METROPOLITAN GOVERNMENT OF NASHVILLE AND DAVIDSON COUNTY

STAFF RECOMMENDATION
1107 Lillian Street
March 19, 2014

Application: Demolition; New construction – infill; Setback determination
District: Lockeland Springs-East End Neighborhood Conservation Zoning Overlay
Council District: 06
Map and Parcel Number: 08313012800
Applicant: Troy Stackhouse, Odyssey Construction
Project Lead: Sean Alexander, sean.alexander@nashville.gov

1 Historic - Site Plan
1/16" = 1'-0"

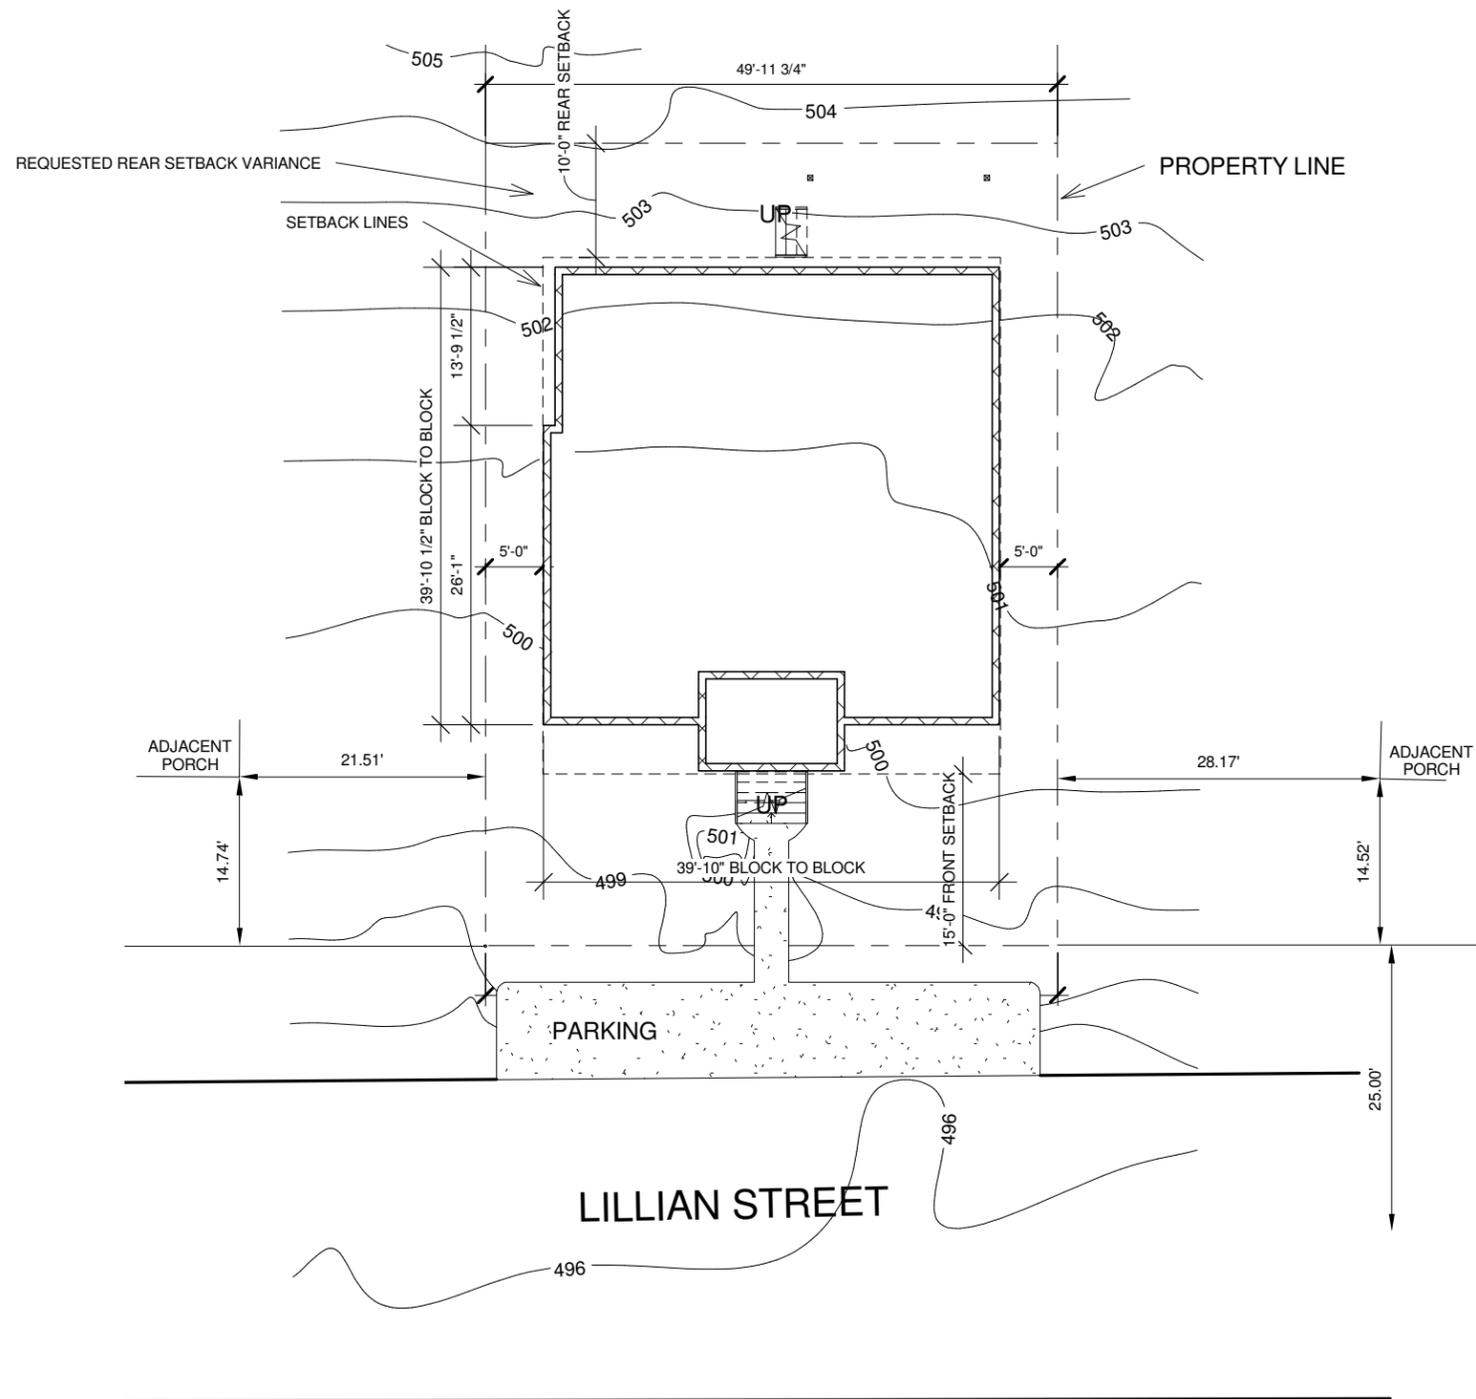
The front of the new house will be aligned with the adjacent houses, with a five foot (5') setback on each side. These setbacks are compatible with the surrounding context and will maintain the established rhythm of the street. The rear of the house will be ten feet (10') from the rear property line. Although the house is only forty feet (40') deep, it would encroach into the standard rear setback buffer because the lot is only seventy-feet (70') deep. Other lots on this block are greater than one hundred feet (100') deep. Staff finds that the location of the structure, in relation to other structures, is compatible and that the proposed setbacks are appropriate given the unusual size of the lot. Staff finds that the new house will meet guideline II.B.3.

two-car parking area at the front of the property, parallel with the street. This location for parking is appropriate because of the lack of alley access and the unusual size of the lot. Although the existing non-contributing house has a driveway on the left side of the house, front parking is typical of most houses on this block. Staff finds the orientation of the new house to be compatible with the surrounding context and to meet guideline II.B.6.

1 Historic - Front
1/8" = 1'-0"

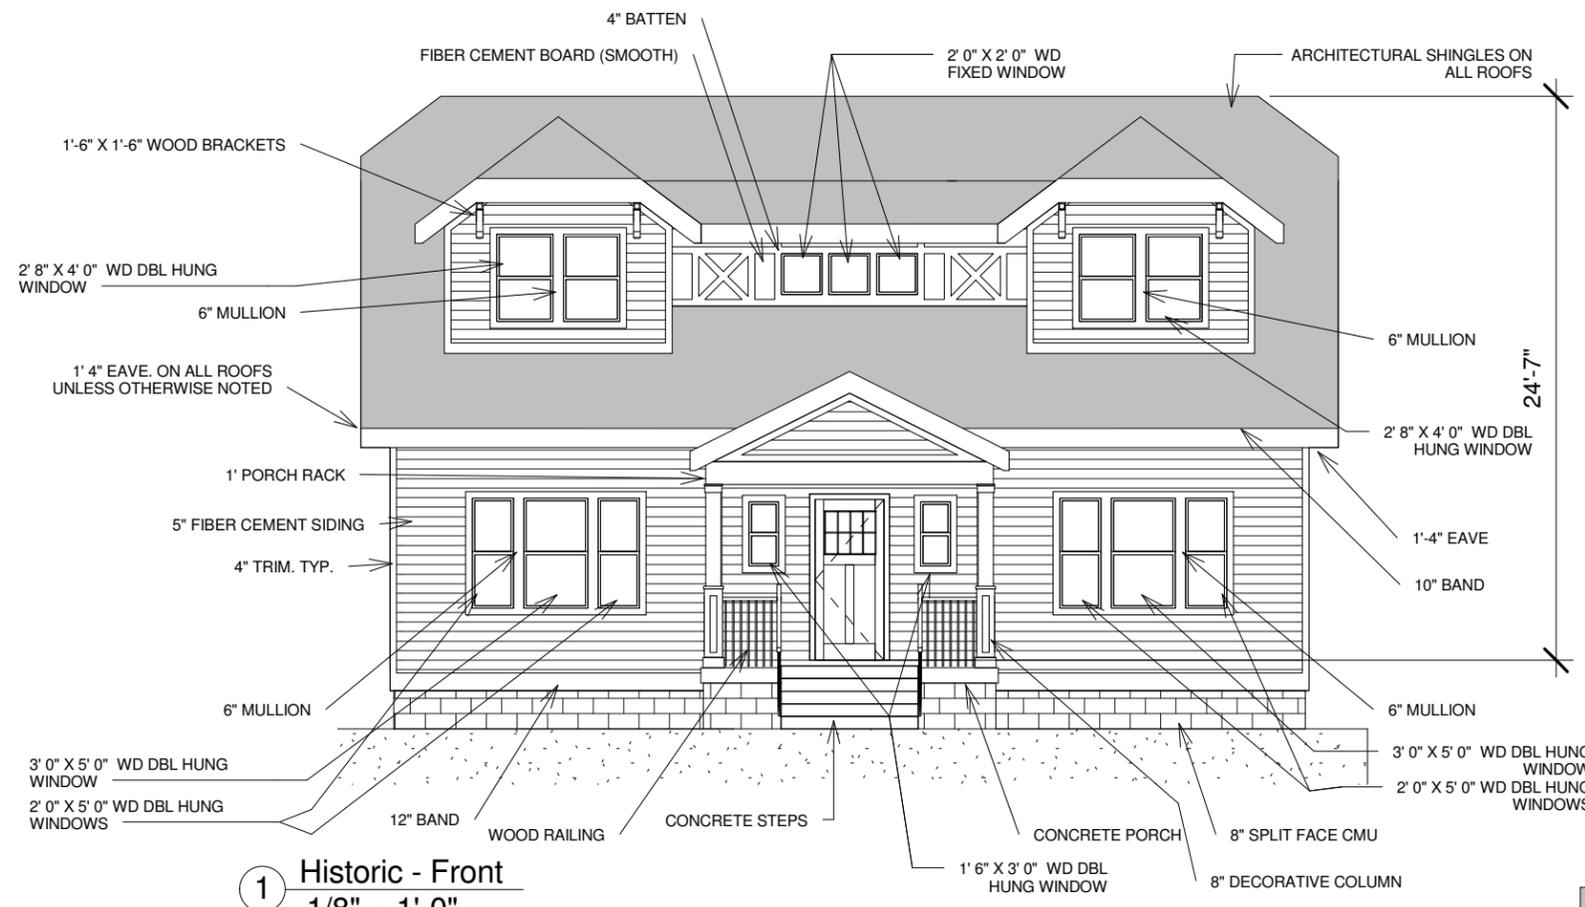
The new house will have one and one-half stories, with a roof ridge height of twenty-eight feet (28') above the front grade. The house will have a floor height at three feet (3') above grade, with approximately two feet (2') of exposed foundation and a twelve inch (12") water table band below the floor level. The eave height of the new building will be twelve feet (12') above grade. Historic houses nearby range between fifteen feet (15') and thirty feet (30') tall. These heights are compatible with surrounding historic houses.

The roof of the new house will be a side-oriented gable, clipped at the ends, with a pitch of 12:12. To give the house a functioning second story, the front slope of the roof will have a three-part-dormer with clipped gables on each end connected by a shed-roofed section in the middle. Although not common in combination, the individual elements of the dormer are very common throughout the district. By setting the shed-roofed section back from the gables and breaking up the dormer into three components, as opposed to having one large dormer, the scale is broken up in a way that the appearance will be compatible with form of surrounding historic houses. In addition, this type of dormer, although rare, is not completely without precedent. See image above.

The new house will have an eight foot (8') deep by twelve foot (12') wide front porch, partly recessed into the center of the front elevation. Prominent porches engaging the street are important features throughout the district, and the recessed porch allows the form of the new house to be compatible with surrounding houses without interrupting the rhythm of the street established by consistent front setbacks. The front porch will connect to the street with concrete stairs and a paved walkway. There will be a paved

Staff recommends approval of the application to demolish the existing house at 1107 Lillian Street and to construct a new one and one-half story house, with conditions that the color of the roof, the material of the windows and doors, and the location of HVAC are approved by Staff. With those conditions met, Staff finds that the application meets the design guidelines for the Lockeland Springs-East End Neighborhood Conservation Zoning Overlay.
